Meeting with representatives of Scott's Restaurant, the Port of Oakland and BCDC

**Subject:** Finally a response to your email of July 25th 2014 Public Pavilion - Scott's Restaurant - Jack London Square

Material Amendment Request for Permanent  
Outdoor Structures at Scott's Jack London  
Seafood Restaurant

**Subject:** BCDC Permit Application Nos. 1985.019 A and B

**PAVILION  
FLOOR PLAN**

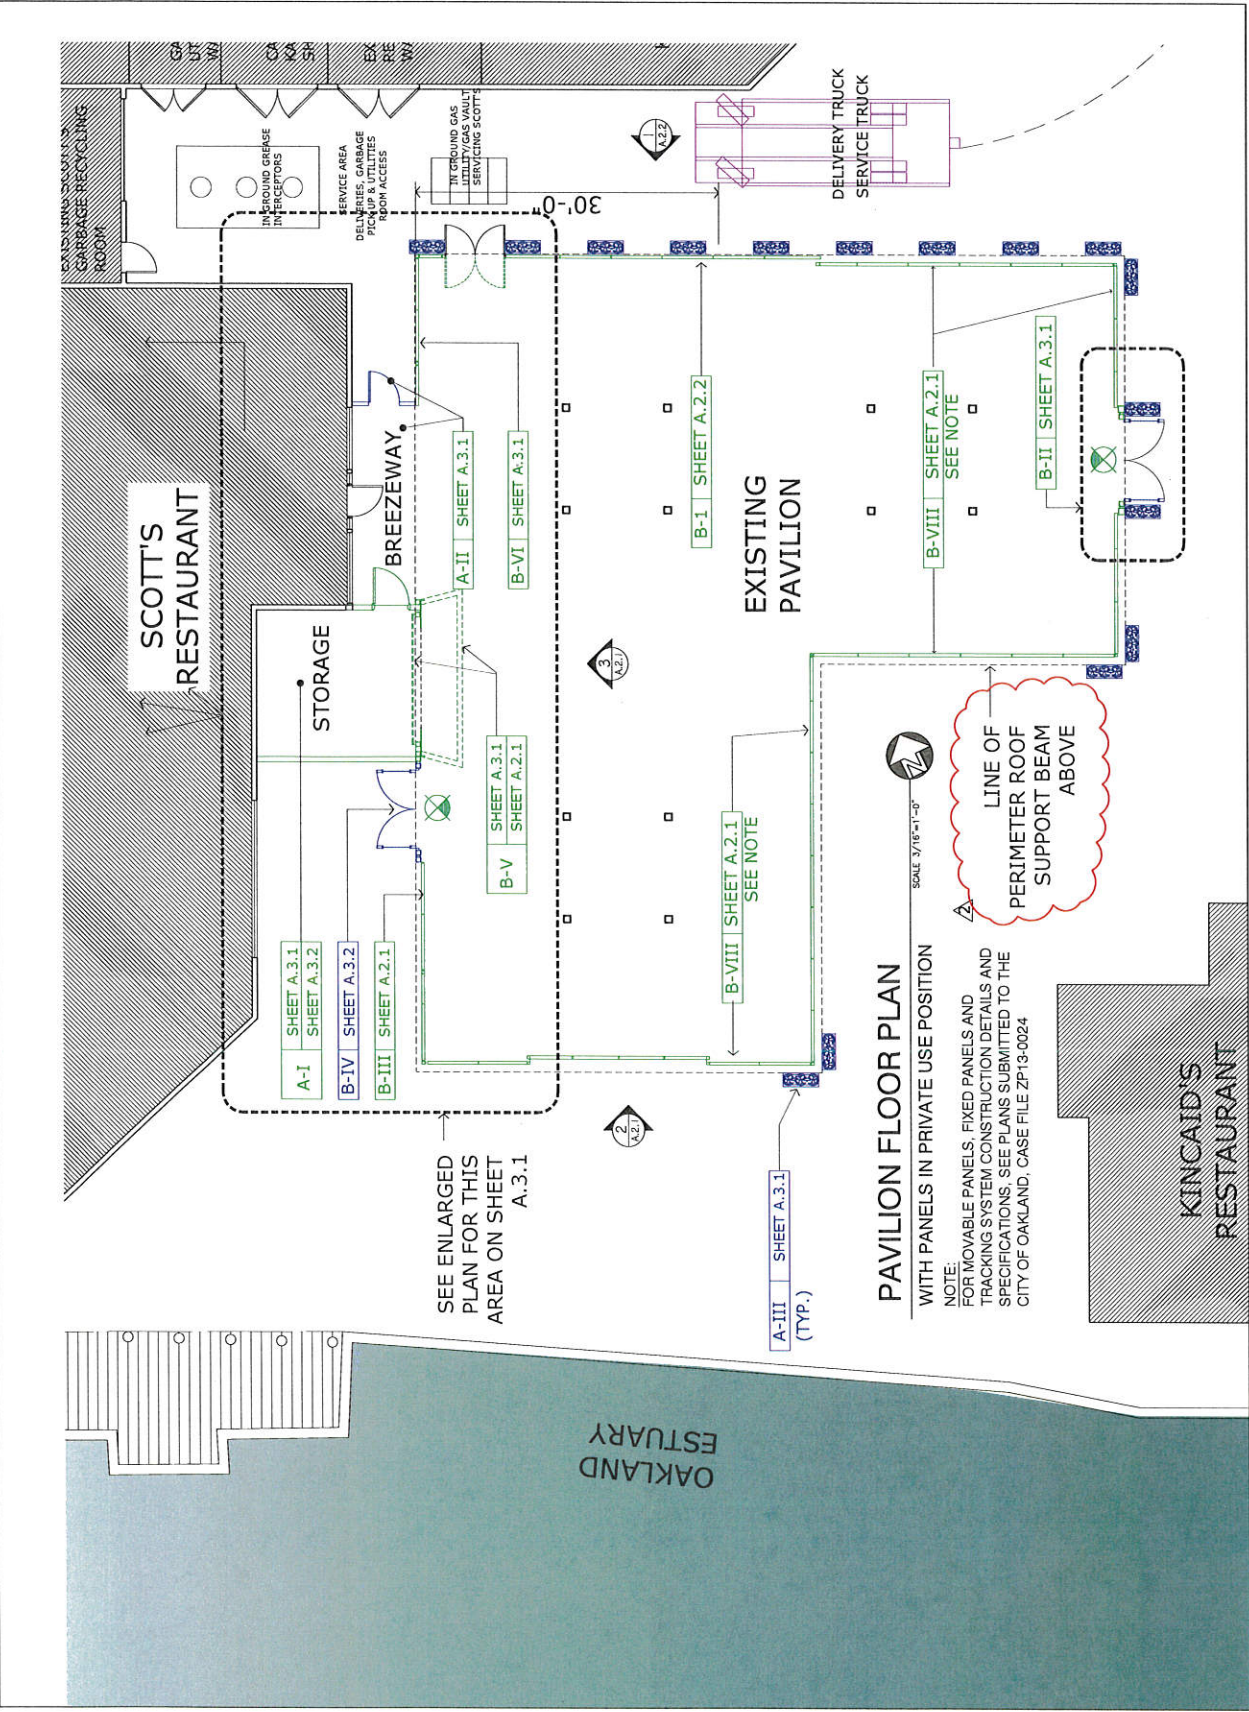
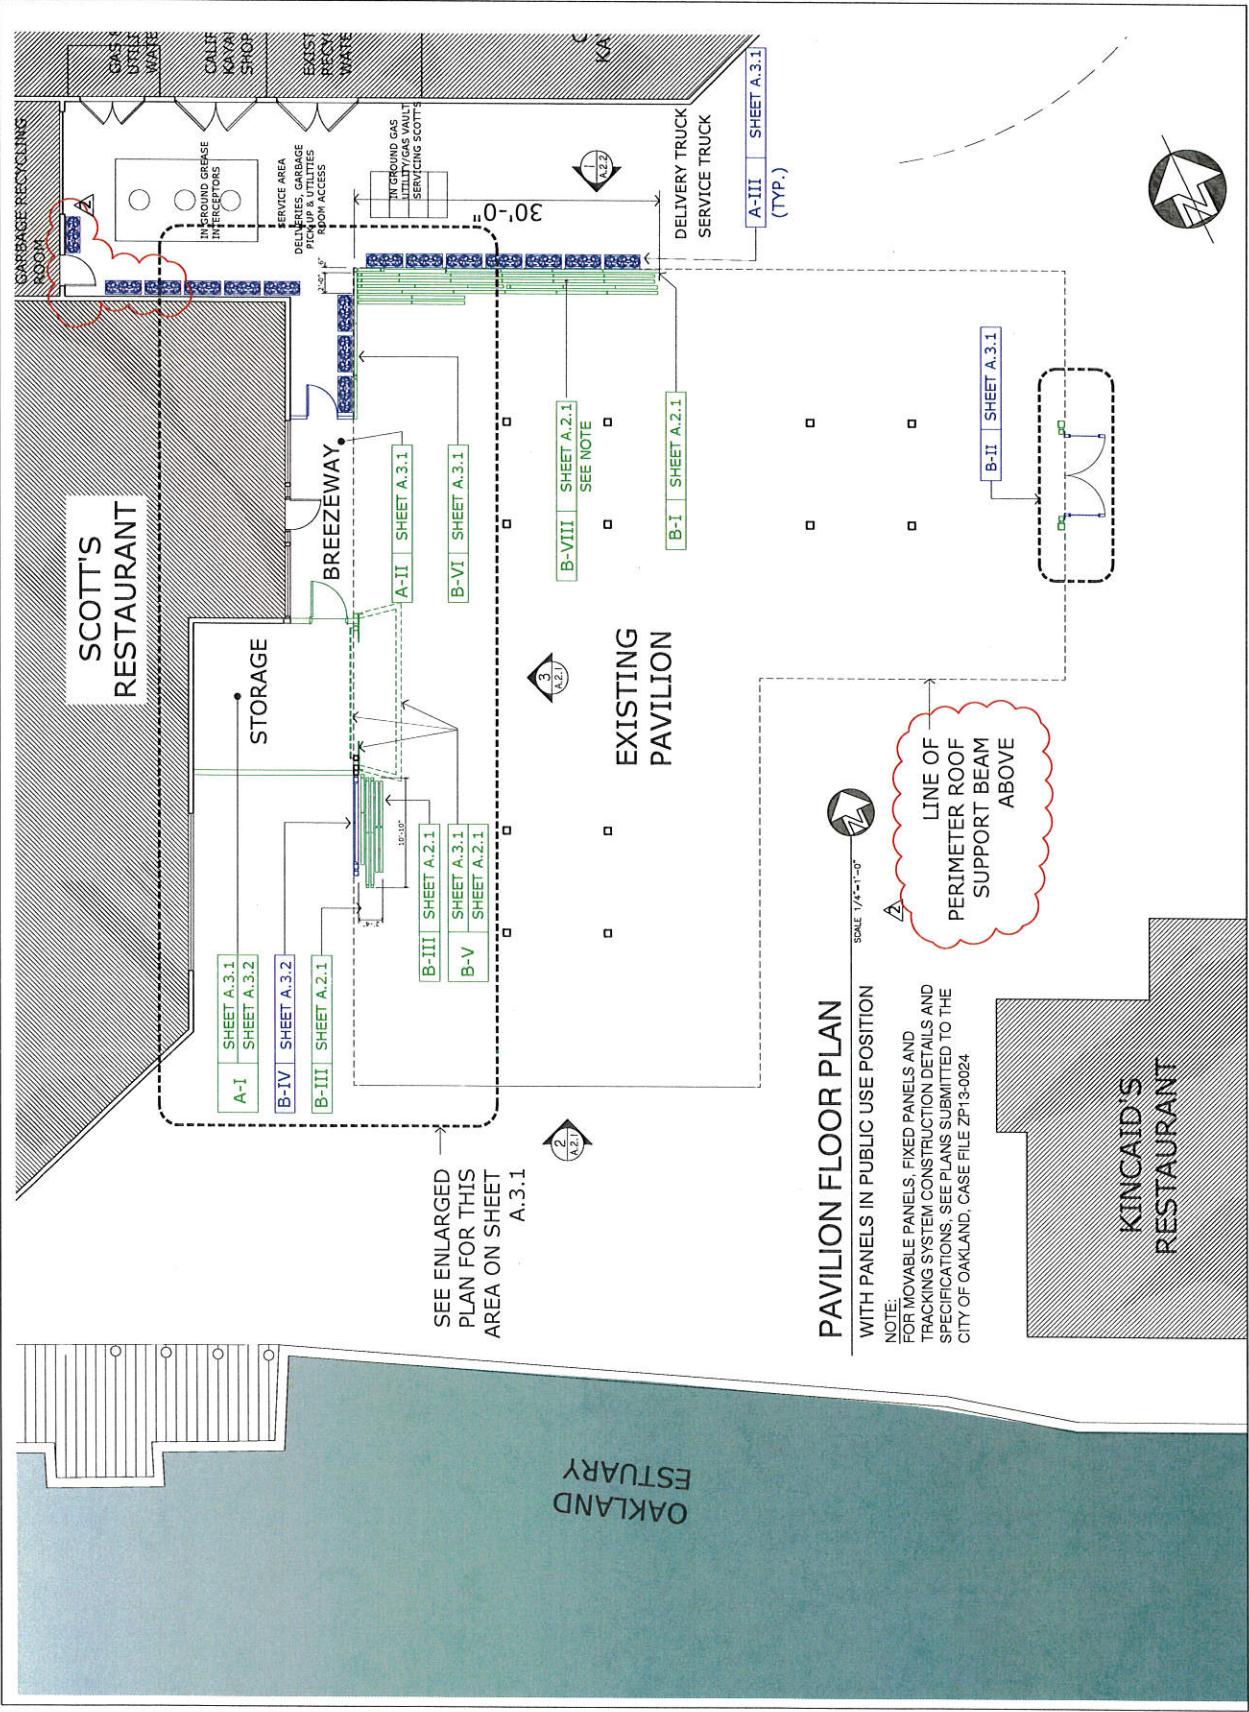
(BCDC)-B. Your plans depict that you will locate all of the planters within BCDC's shoreline band jurisdiction, however, your letter indicated that fewer than the total number will be stored in the shoreline band. Please clarify whether or not all 16 planters are proposed within the shoreline band.

(BCDC)-A. Please revise Sheets A.1.1, A.1.2, A.1.3, and A.3.1 to remove the two black lines between the breezeway and the stage, which appear to depict a wall where no wall is proposed.

A. Please revise Sheets A.1.1, A.1.2, A.1.3, and A.3.1 to remove the two black lines between the breezeway and the stage, which appear to depict a wall where no wall is proposed.

(Response)-B. We apologize for the lack of clarity here. Since it was determined that the entire Pavilion, including the southern edge of the Water Street I Building is within the shoreline Band it is necessary to retain all of the 16 proposed planters within the BCDC jurisdiction area. As depicted in our most recent plan submittal on Sheet A.1.2 (newly revised date 09/01/2014) the planters will be stored along the north edge of the Pavilion's north wall storage system as well as within the breezeway area. This area is the loading and service area for both the Water Street I Building and Scott's Restaurant and we feel that this area is least impacted by the storage of these planters when the Pavilion walls are stored in the public use position. The planters are heavy enough as well, to protect the north wall system during times that deliveries, trash and other services are being performed by large trucks. As we have agreed in our earlier communication, when the Pavilion is in its Private-Use mode many of the planters will be redeployed to other strategic locations just outside of the wall system's perimeter.

These locations are depicted in the most recent submittal on Plan Sheet A.1.1 (newly revised - 9/01/2014).

(Response)-A. We have made those revisions, and we hope this clarifies this, the new dashed lines represent the perimeter roof line for the Pavilion.

SHEET NUMBER  
SCALE AS NOTED  
**A.1.4**

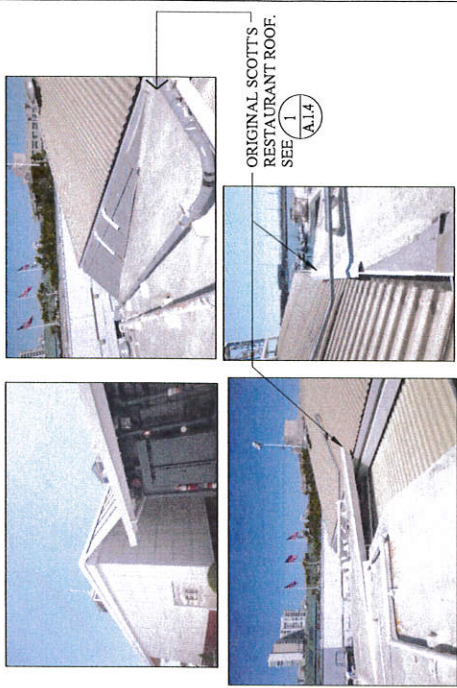
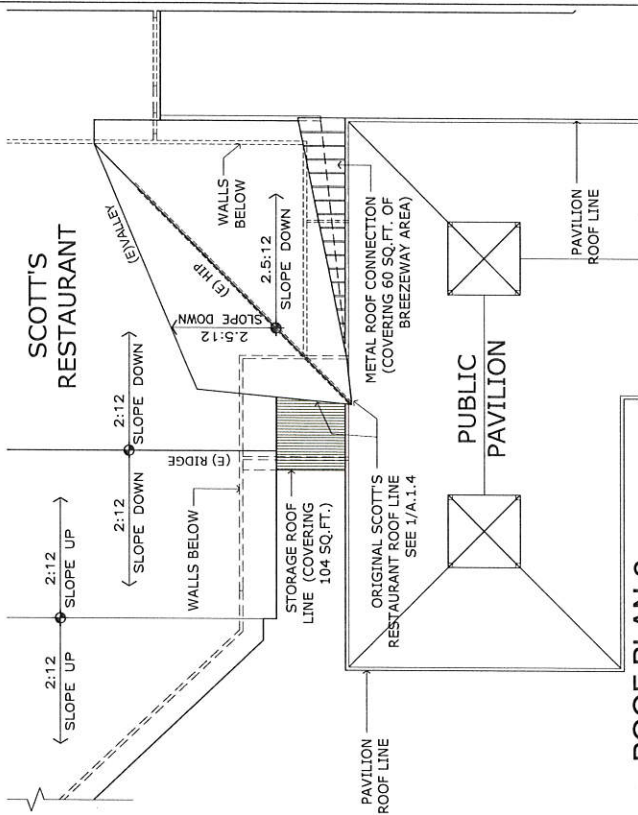
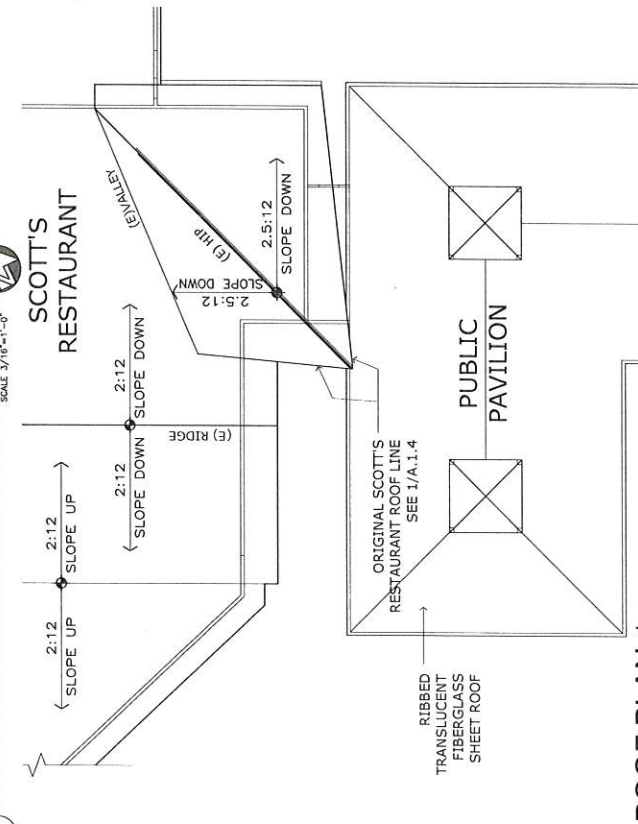
(BCDC)-D. Please create a new sheet depicting the former rooflines of Scott's Restaurant and the Pavilion as they existed prior to construction of the storage area and breezeway, and depicting the current joined rooflines as they exist today.

D. Please create a new sheet depicting the former rooflines of Scott's Restaurant and the pavilion as they existed prior to construction of the storage area and breezeway, and depicting the current joined rooflines as they exist today.

(Response)-D. We have created these plans and included them as part of the new plan sheet labeled sheet A.1.4. It should be noted that the existing roof plan for Scott's restaurant (formerly the Sea Wolf restaurant) was not changed substantially from its original design when the restaurant was built in the early 1950's. The roof design of the Sea Wolf included extensive roof overhangs that jutted out to exaggerated points as an architectural effort to depict the sharp bows of a ship. This roof line in the east (rear) of the restaurant was a reflection of the more prominent roof lines near the front door of the restaurant.

As noted, on Sheet A.1.4., on the roof plan illustration on the left, (entitled: Roof Plan 1 - *Prior to Construction of the Storage Area and Breezeway*) the restaurant roof extended to and overlapped slightly the newer Pavilion roof's edge at one of its points. The roof line is also depicted in the "Approved BCDC Site Plan" copied in the drawing on the top of Sheet A.1.4. as a dotted line as noted on the drawing. On the illustration on the lower right of Sheet A.1.4. (entitled: Roof Plan 2 - *Current Roof Condition*), the illustration shows that there was in fact a more recent connection between the Pavilion and Scott's consisting of a standing seam metal roof. This connection overlaps the both roofs but covers 60 sq. ft. of the area in what is proposed as the breezeway between the two buildings.

Also noted in this drawing on Sheet A.1.4., the lower right illustration (Roof Plan-2) shows the extent of the storage building roof and including the fact that that roof covers an area of 104 sq. ft. Since there are overhanging roofs on both sides the roof for the storage building covers less space than the storage buildings floor dimensions at 255 sq. ft.

Finally on the top right hand side of Sheet A.1.4., (1/A.1.4) there are photographs of the current roof configuration showing for example the standing seam roof connection over the breezeway (from the perspective of both bottom and top) and the roof section covering the storage room. We have additional photographs which we can provide as part of our submittal if that would clarify these roof connections further.

**PAVILION  
ELEVATIONS**

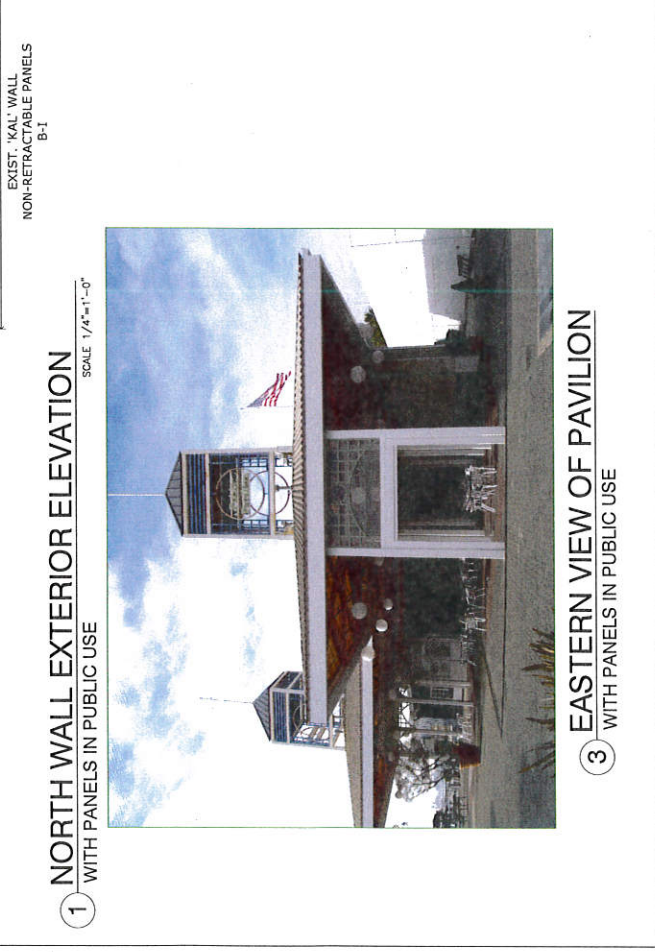
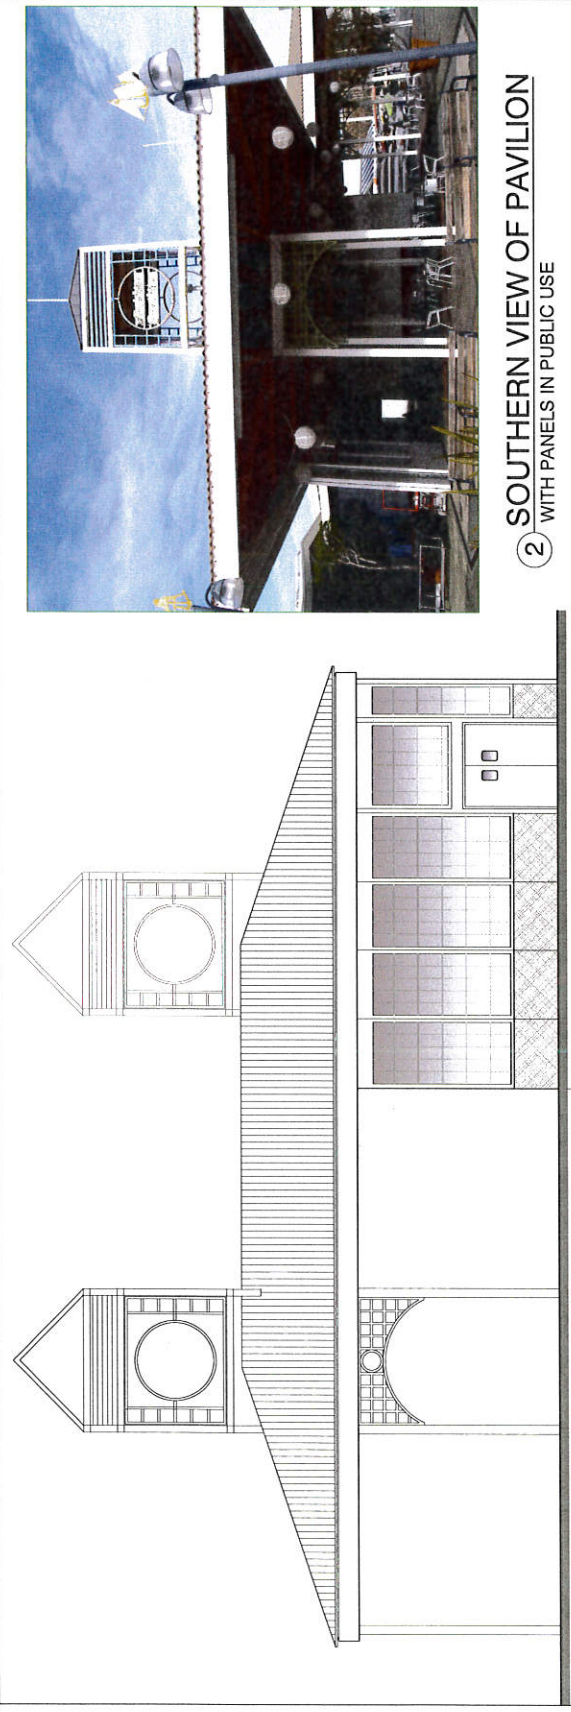
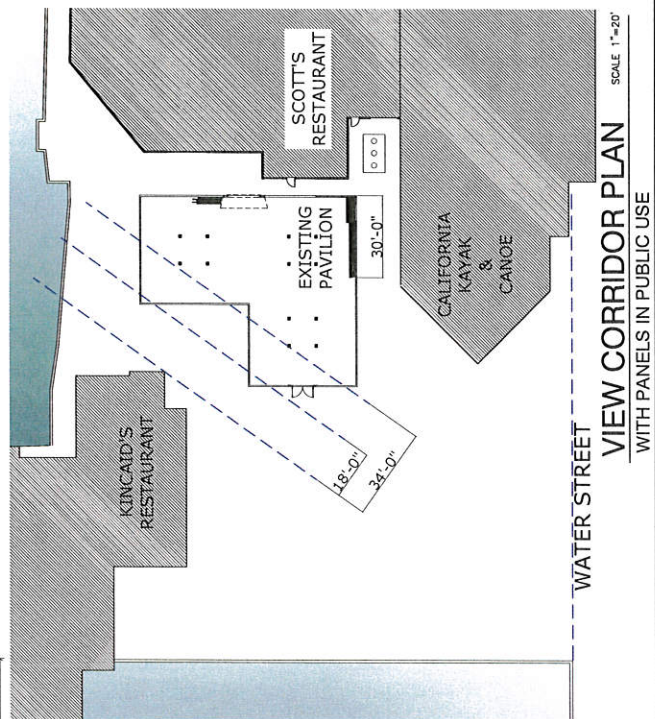
a. (BCDC) The 40-foot-long section of the exterior non-retractable wall on the north side of the pavilion and door, which is already constructed. As you know, we have directed you on numerous occasions to shorten this wall from 40 to 30-feet so that it does not impact views to the Bay. We have also stated that at 30-feet in length, we may approve it through plan review. However, as you now want to retain the as-built length of 40-feet (please clarify) and install a door in this permanent wall (also as built), it may not be approved through plan review and must instead be considered by the Commission as part of this material amendment. The existing permit authorizes the enclosure of the pavilion with removable canvas panels. Two years ago, when you proposed replacing them with retractable wall panels, we determined the proposal was sufficiently equivalent in design and nature to the existing authorization to enable an in kind replacement through plan review. However, this element of your self-described "design-build" pavilion enclosure exceeds the intent of the existing authorization;

(7) Transparency - Can you add ~~more~~ more windows. Steve says it's a dump. Sheet A.2.1 - Ellen asks for more windows on main entrance and waterfront sides. ~~Steve~~ Peter says people want privacy. These panels are more translucent than tent panels. New structure is an improvement.

a. (RESPONSE) We understand the concerns expressed by BCDC on this issue and have agreed to your comments and will submit a revised application depicting the north wall elevation extending no further than 30 feet when in public use. This location is where many of the movable walls are stored and therefore, they will have to be rearranged on additional parallel tracks so that they do not extend beyond 30 feet while stacked in place for public use. This requires some re-engineering but is something we can do.

- b. (RESPONSE) If I am understanding this correctly, we have answered this concern in item a. above. We intend to reduce the north wall from its present 40 feet of permanent wall to 30 feet and then reposition the track system so the stackable/moveable walls will stack within the dimensions of the 30 foot permanent wall on the north end of the Public Pavilion. Two of the permanent wall sections will become movable and stackable within the new shorter 30 foot length of the permanent wall.
